Bradley Heights Apartments

A 236-Unit Apartment Development Puyallup, Washington

Bradley Heights SS LLC

SHEET NO. M0.3

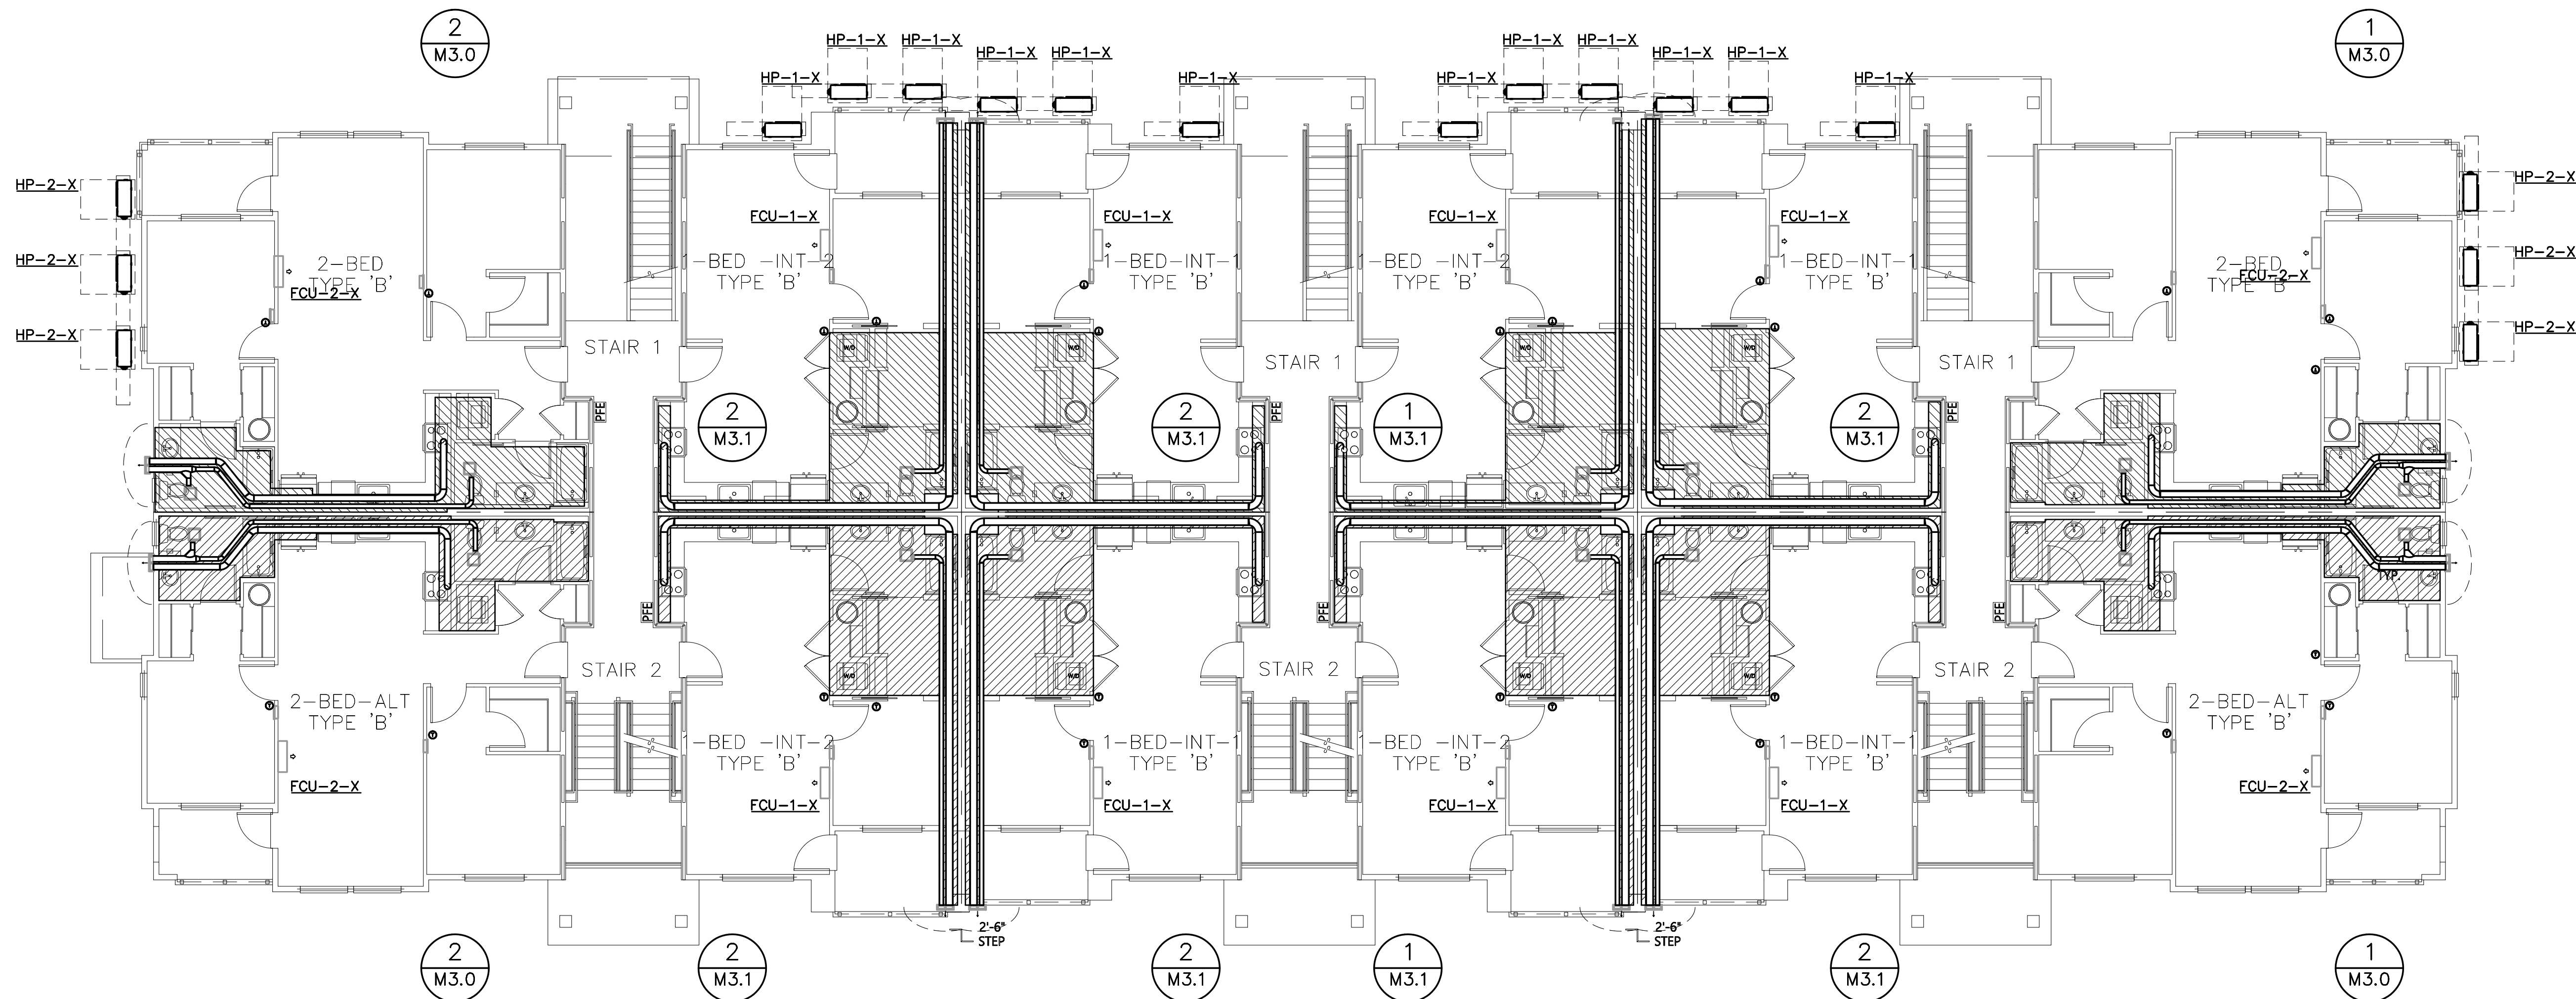
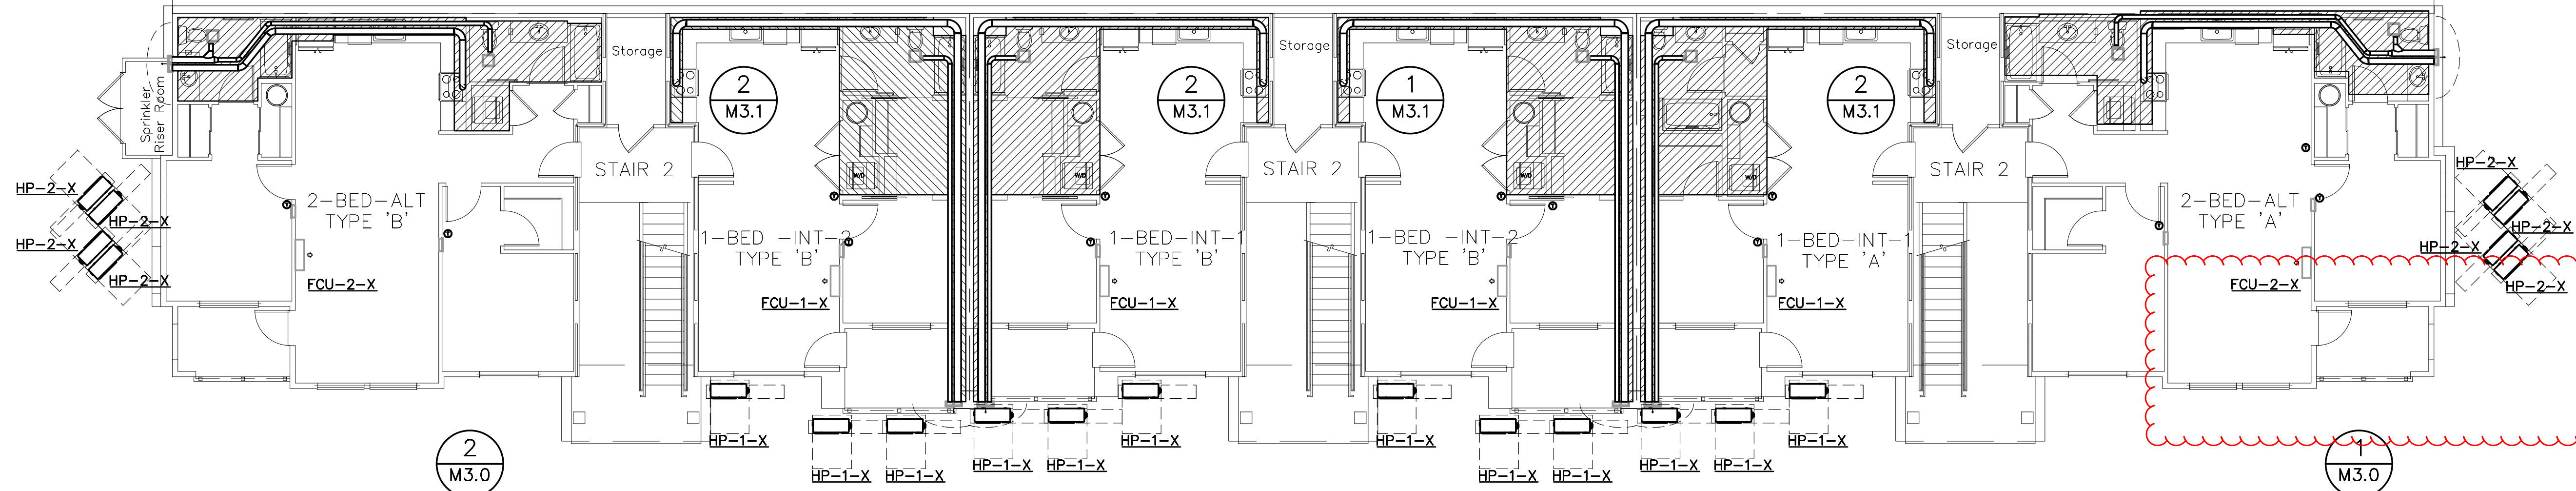
Duct runs for range hoods on interior units appear to be about 63 feet. Provide specifications on range hood that will accommodate a long run.
(Construction Set, Sheet M2, M2.1 and M3.1)

SHEET NO.
M2.0

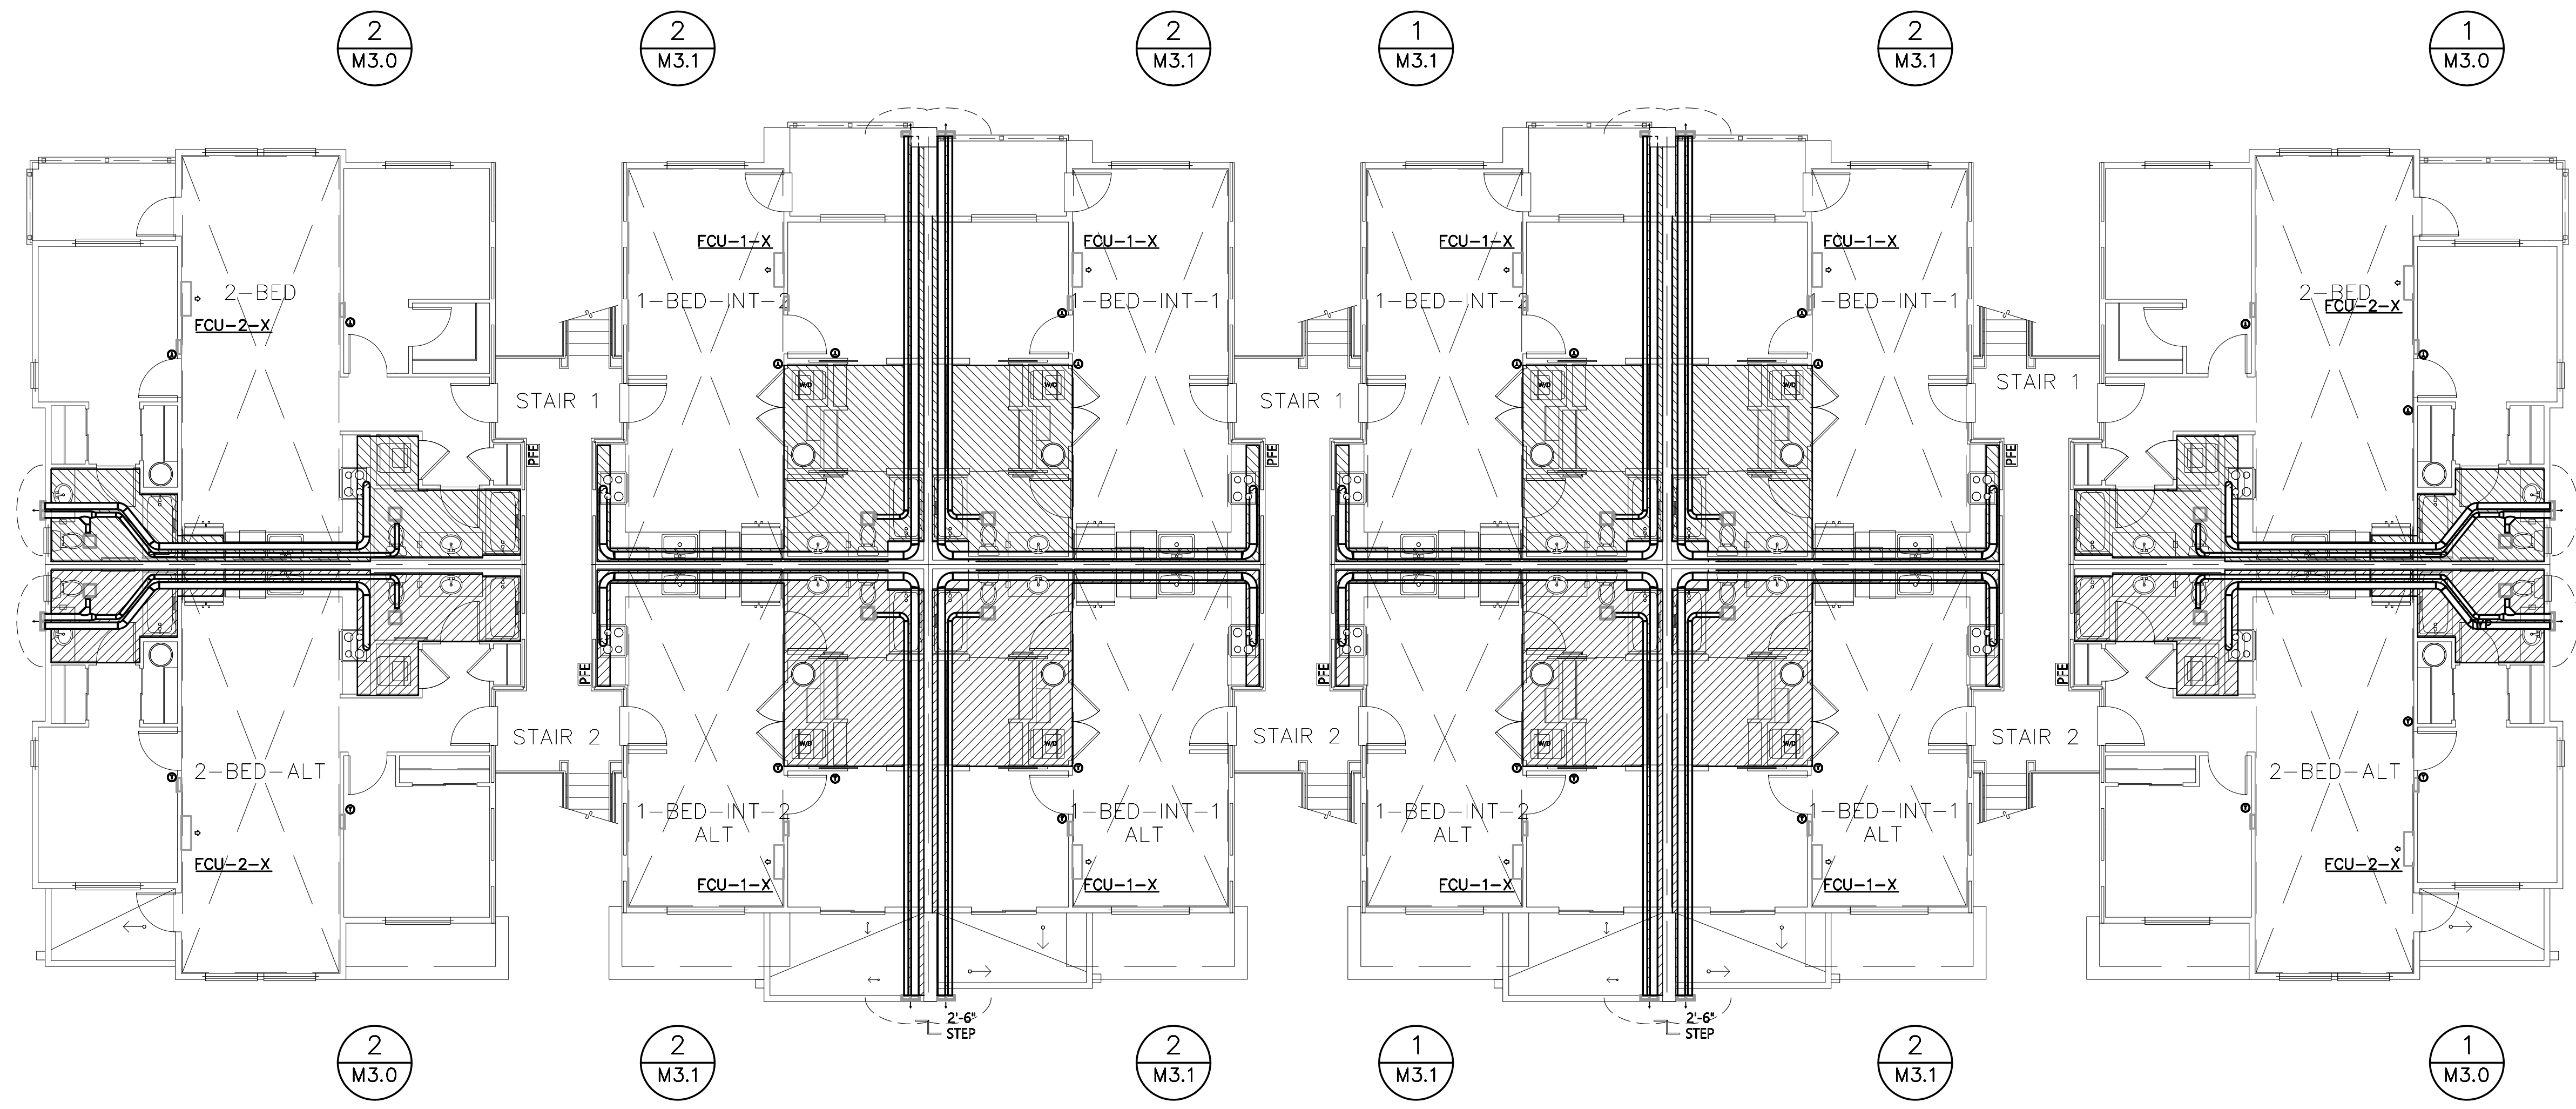
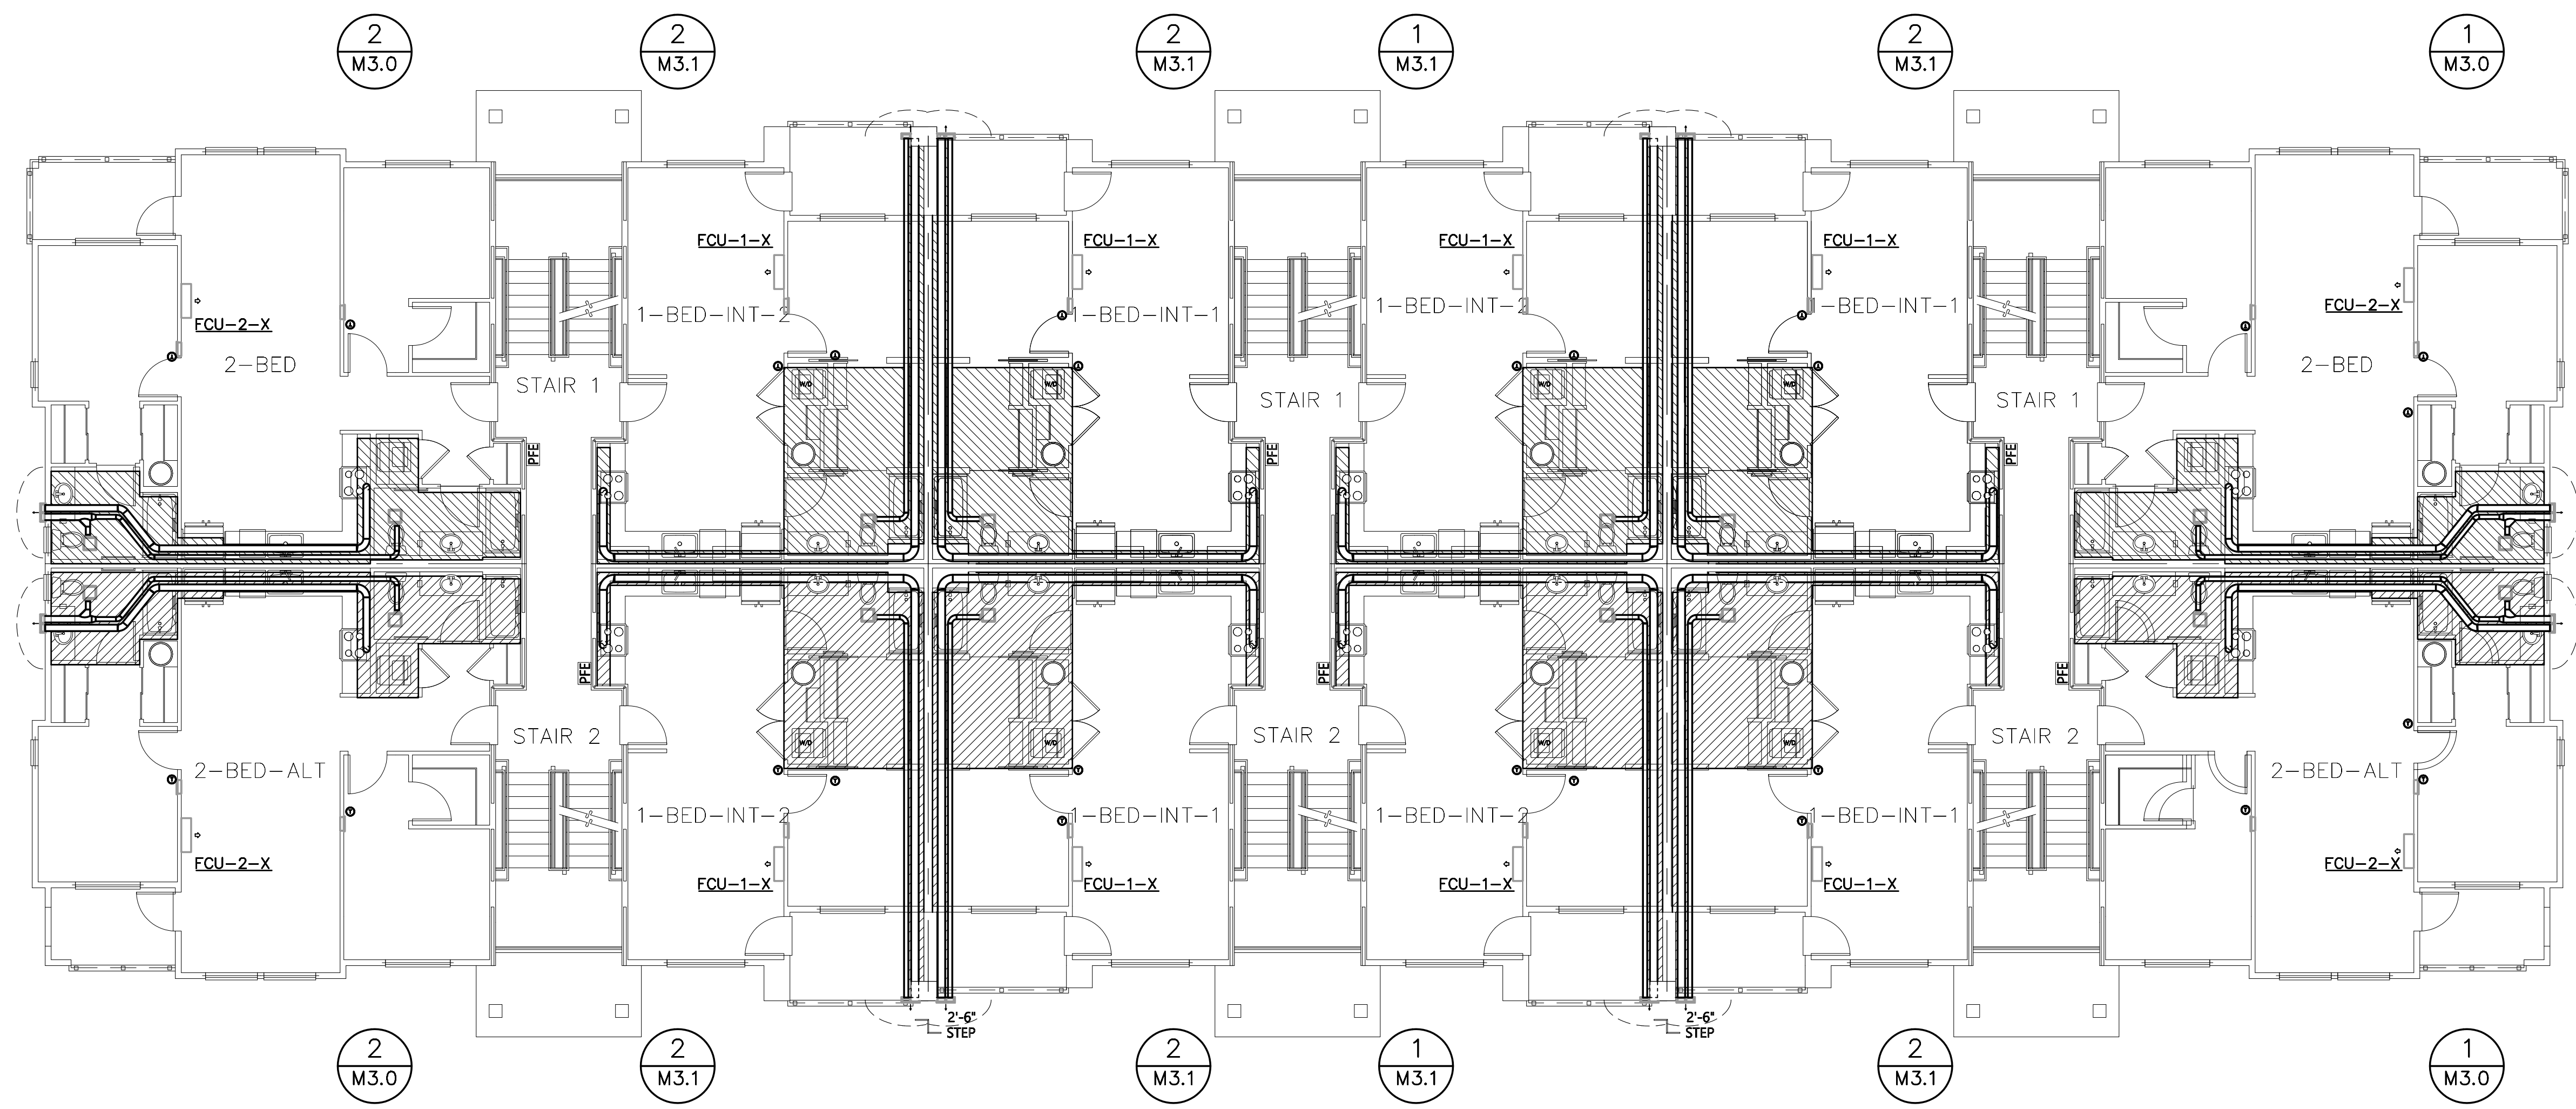
There are two duct runs that appear to terminate in the sprinkler riser room. The ducts are within a furred down ceiling to 8 foot and riser room is between the 1st floor and basement. Review and adjust plans as needed.
(Construction Set, Sheet M2, 1st Level Plan)
